Council Assessment Panel

Meeting Agenda

Monday, 28 October 2019, at 5.30 pm, Colonel Light Room, Town Hall, Adelaide.

3.1 Subject Site 69-79 Gilbert Street, Adelaide SA 5000 [Page 11]

PROPOSED GROUND FLOOR PLAN
Scale 1:100 @ A2

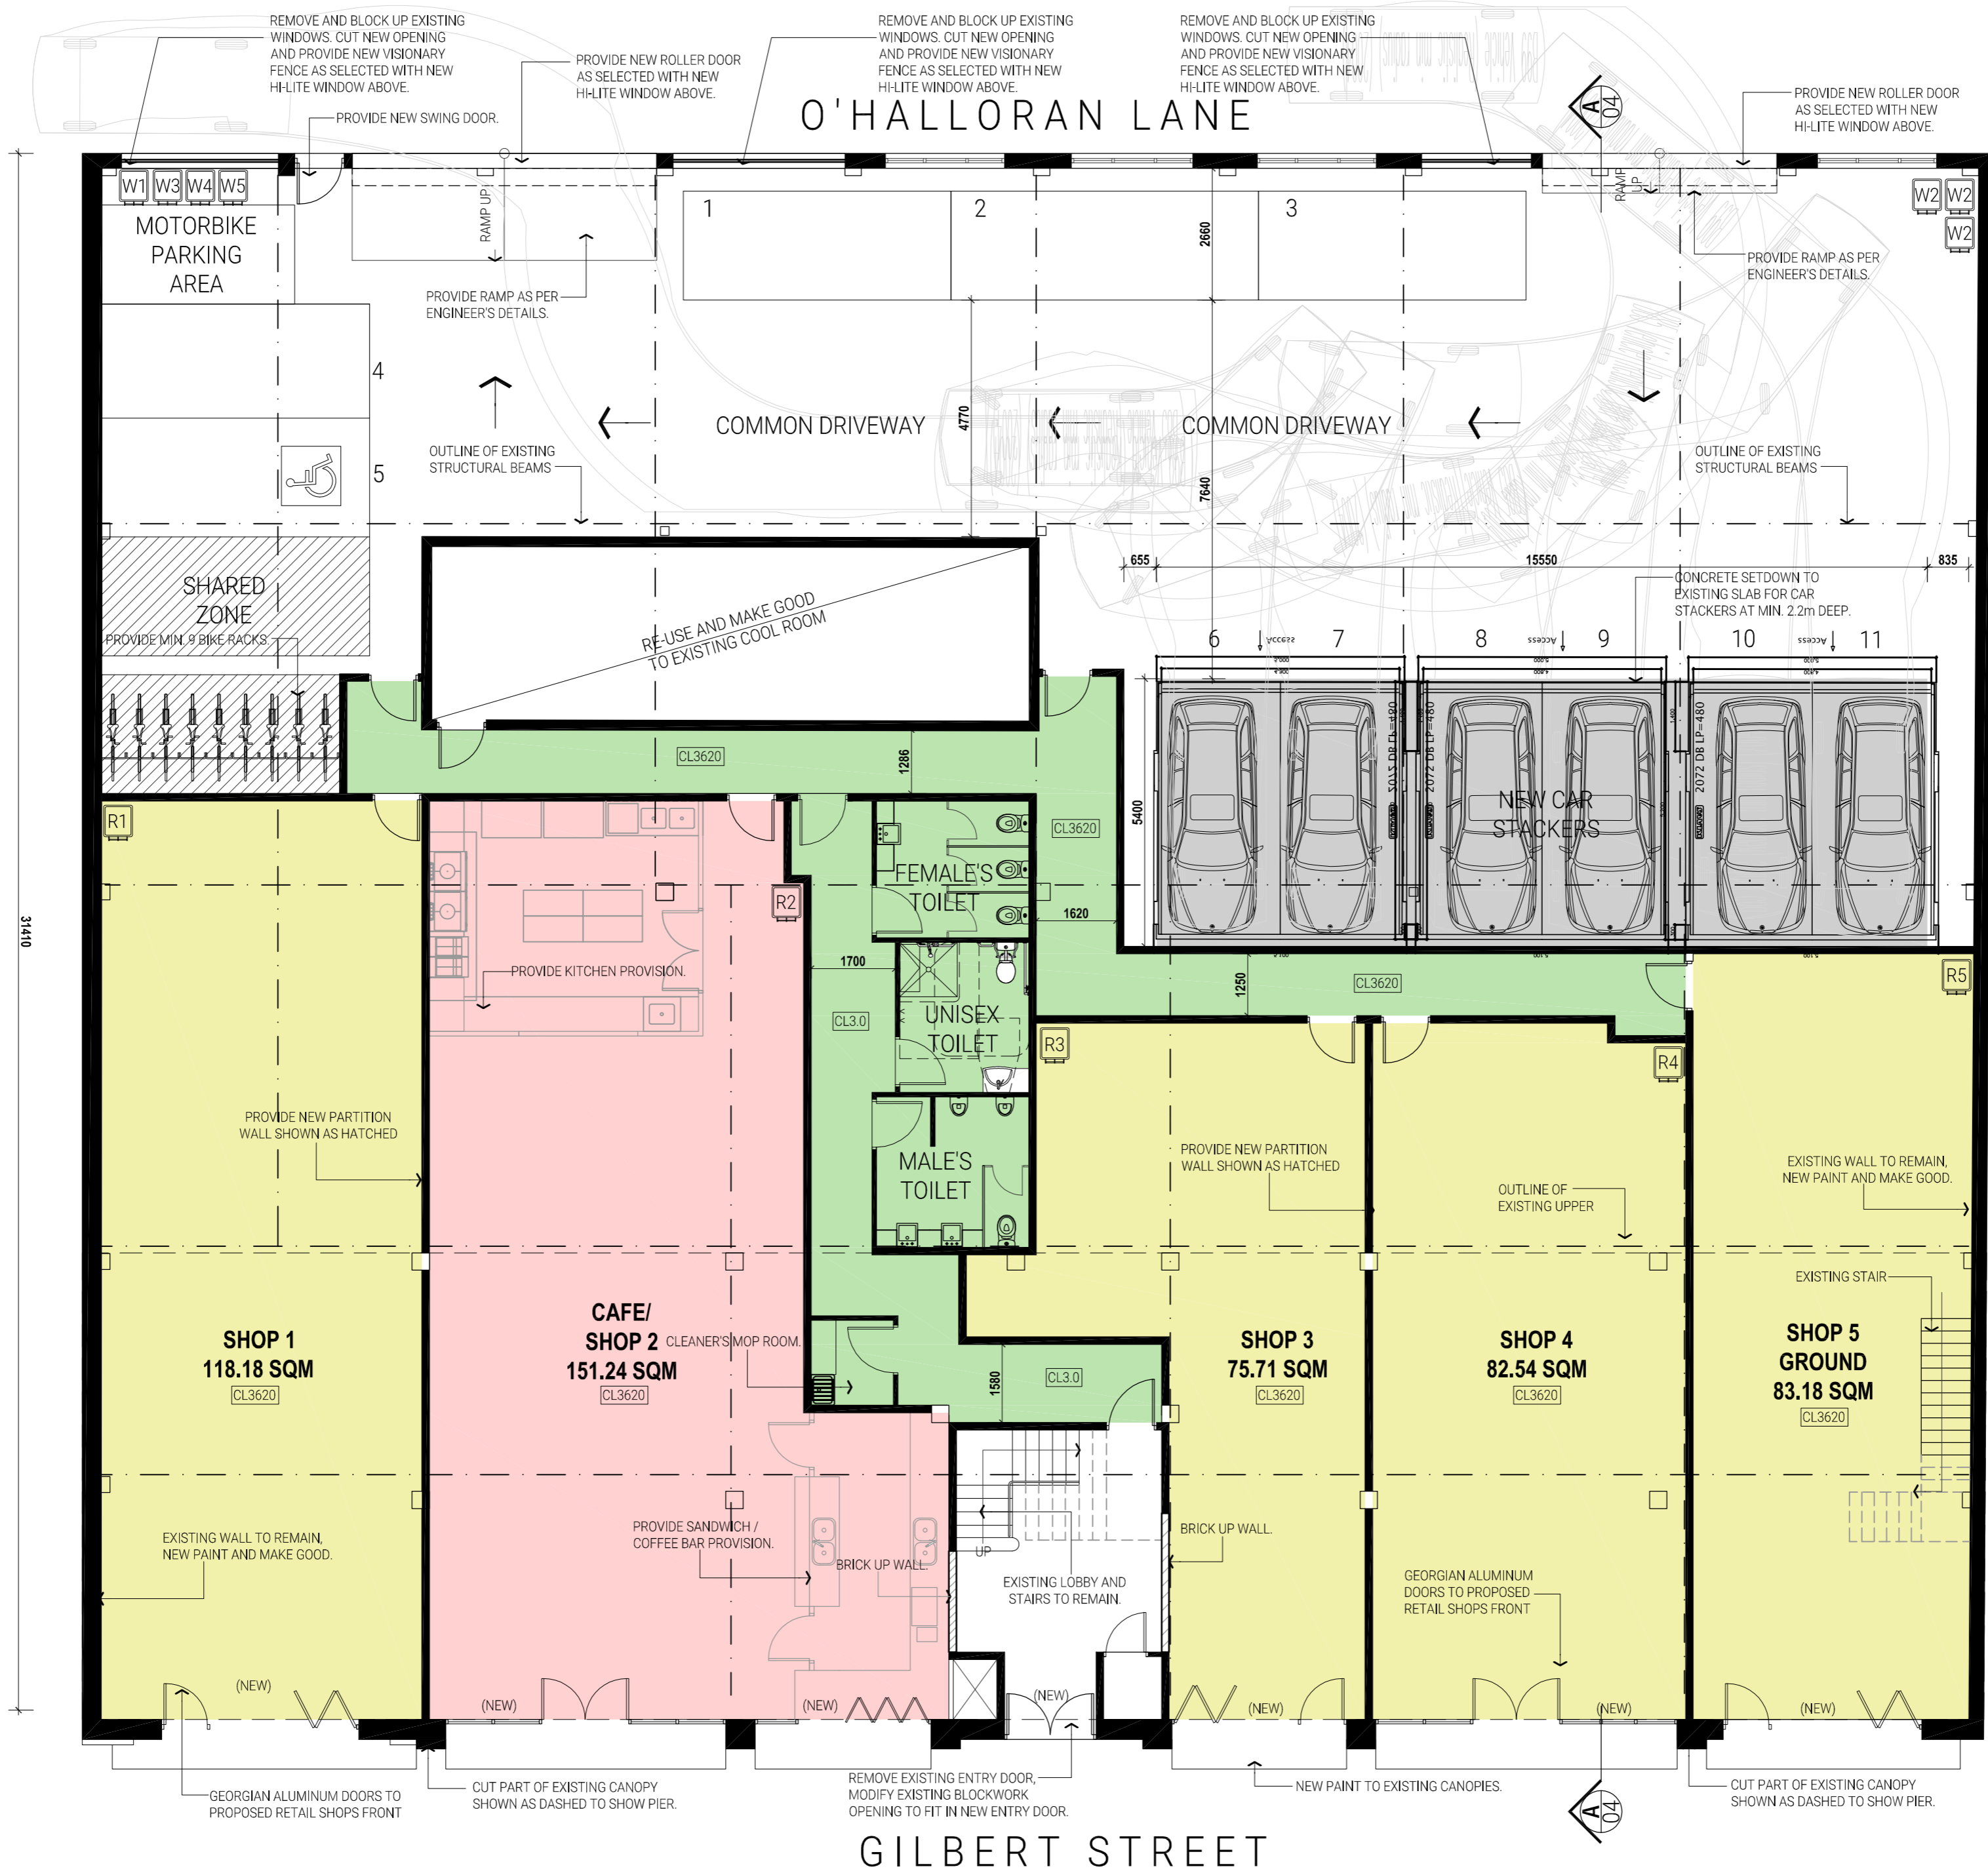
Summary of Representations	Applicant Response
Potentially noisy car-stacker system proposed adjacent bedroom and living room wall of neighbouring property at 81 Gilbert Street will cause a negative impact. Stacker should be placed at the eastern end.	Applicant provided acoustic assessment since notification which confirms proposal will comply with Development Plan requirements.
Proposed entry and exit in O'Halloran Lane not acceptable to residents who use this lane. The lane is narrow with a dead end at the rear of 83 Gilbert Street. The increase in traffic will block the only vehicle access to 81 Gilbert Street. The existing entry and exit should be retained.	Traffic Engineer confirmed a separate entry and exit arrangement (compared with a combined entry/exit) will enable satisfactory access and circulation to parking spaces.
The use of the car stacker will take sufficient time and cause queuing into O'Halloran Lane.	Traffic Engineer confirmed car stacker spaces are expected to be assigned to staff. Access will be associated with staff arriving for work and leaving at the end of the day so there will be minimal turnover of the parking spaces. Considering the small number of stackers involved, delays to cars entering the stackers will be very low which will ensure that cars are not held up in the laneway.

The location of the proposed car parking entry door is likely to cause car park users to encroach on the private property of residential sites along O'Halloran Lane. Should be moved eastern end of the building instead of the western.	The turn path diagram provided in the traffic report shows that an entering car will not encroach into private property when turning in.
O'Halloran Lane is only wide enough for one car and this plan shows traffic flow in both directions. There is no mention of foot traffic which also frequents this lane.	No specific response provided.
The proposal will reduce the amount	Traffic Report indicates that adequate parking

The current plan proposes a potentially noisy car-stacker system along my bedroom and lounge room wall, which is likely to impact negatively upon my quality of life and mental health.

Further to my initial comments sent 14th of August 2019, I would like to add that the development plans could be adjusted, so that the car stacker system is placed at the eastern end instead, which would go some way to allaying my concerns with the existing plan that has the system situated adjacent to my property wall.

- 3 I have attached technical information on 'Klaus Multi-parking' car-stackers which have been designed to be located centrally within proposed building redevelopment and are not connected to any existing solid masonry boundary walls. This car-stacker system has been designed to be used in residential buildings as well so they have a very quiet operating system. The car-stacker system (not insulated) will emanate a sound level of approx. 60dba (internally) which is acceptable for internal work areas. If you provide sound insulation refer to technical information sheet – 'Sound Insulation', the noise level emanated from car-stacker operation is only 30dba which is a very low sound rating (below any noise sound level concerns for people working within building, let alone any neighbours). The noise emanating from the car-stacker is very low and I don't believe it would be heard by any neighbouring properties. I have seen these car stackers work and there is no noticeable noise concerns. The modern systems now are very efficient and quiet. Again the car-stackers would mainly be used between 8-9am and 5-6pm. Cars if queuing will be queuing from inside the carpark not outside. Please note we are happy to condition that car-stacker system will be

REAR ELEVATION (O' HALLORAN LANE)

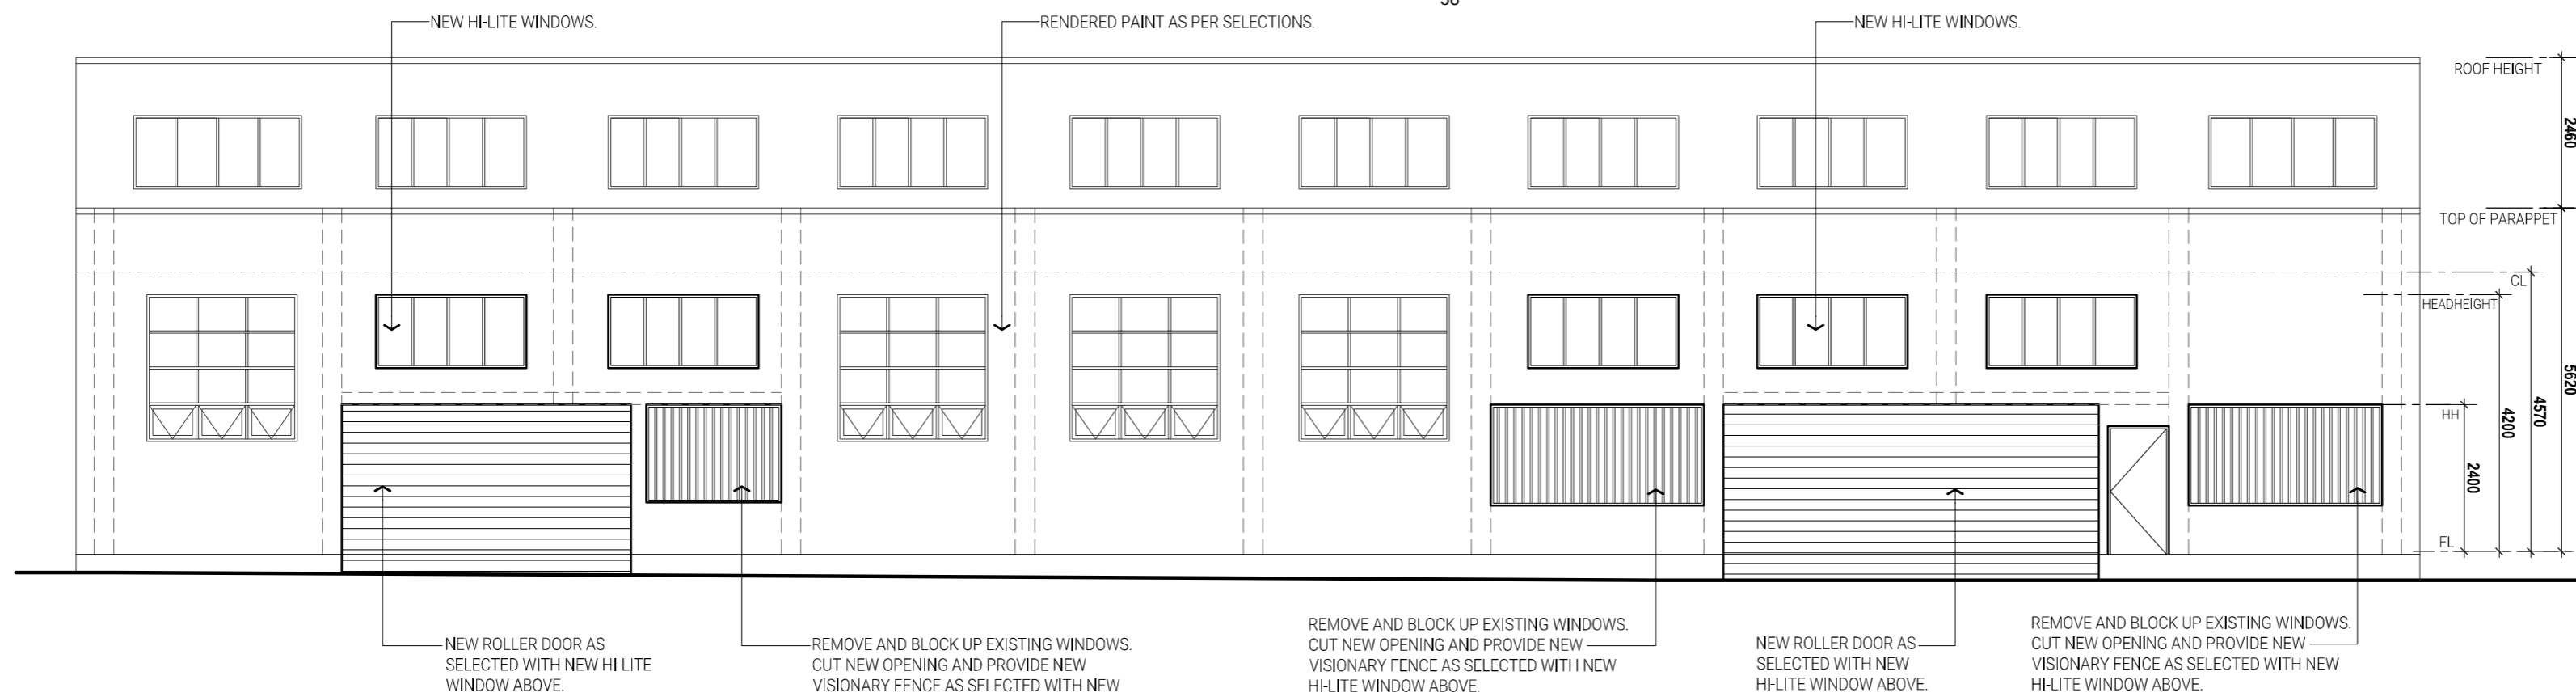
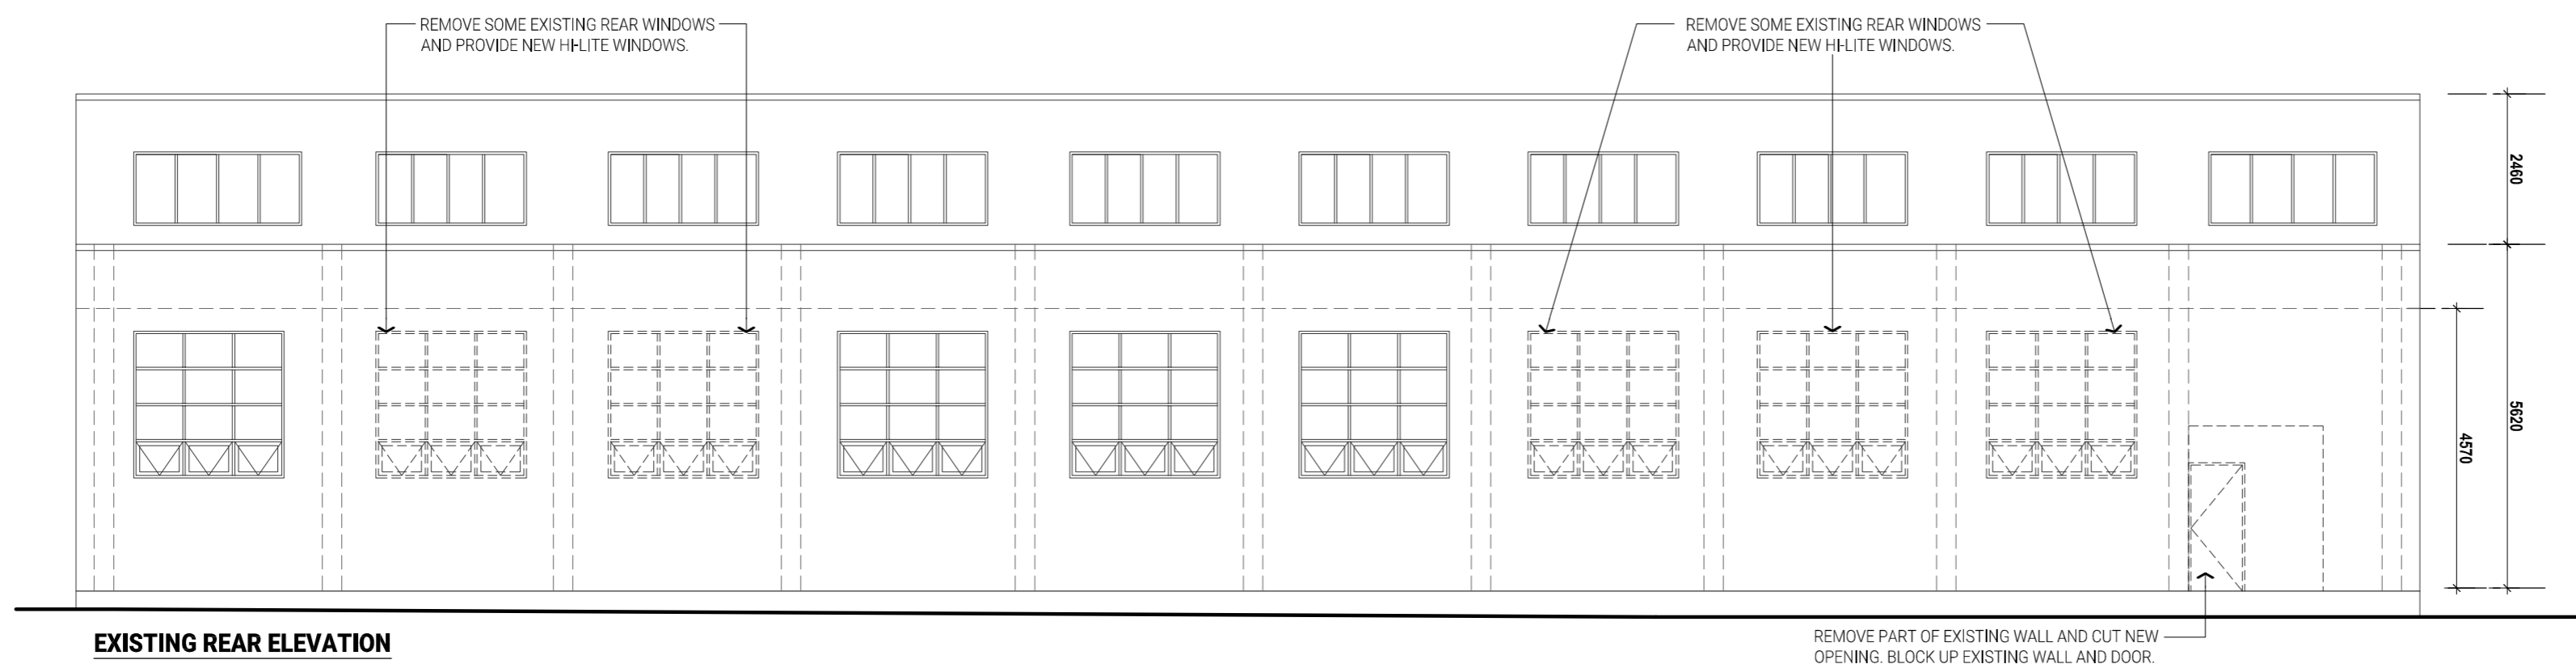
In reference to the plan Rear Elevation (O'Halloran Lane) the proposal of a garage door will affect the visual amenity of my property resulting in loss of value. Traffic will increase in the laneway, whilst lights and sounds from vehicles in the early morning and late at night will be noticeable seven days per week.
